## Technical Service Bulletin

| <b>Topic</b>           | Power Steering Noise 4.0 V8                    |
| <b>Transaction No.</b> | 2042624/3                                      |

Figure 1

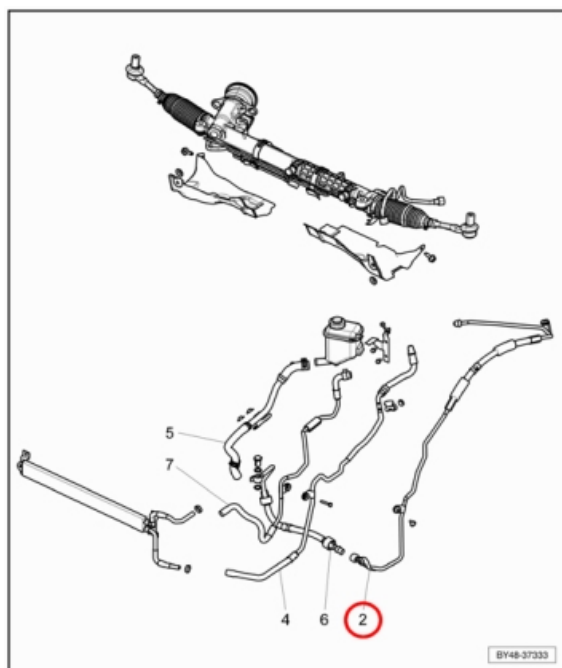
Power steering noise (Hiss) audible in cabin emanating from front of car

Variability in hose assembly and fitting can create noise transfer path at rubber mounting points resulting in power steering hydraulic flow audible in cabin

Design change to improve compliance of hose and thus reduce noise radiation

In the event of a qualified report of power steering hiss audible in cabin then replace power steering high pressure hose (2) (see Figure 1)  
Rep.Gr.48 Power Steering Pipes – To Remove and Fit
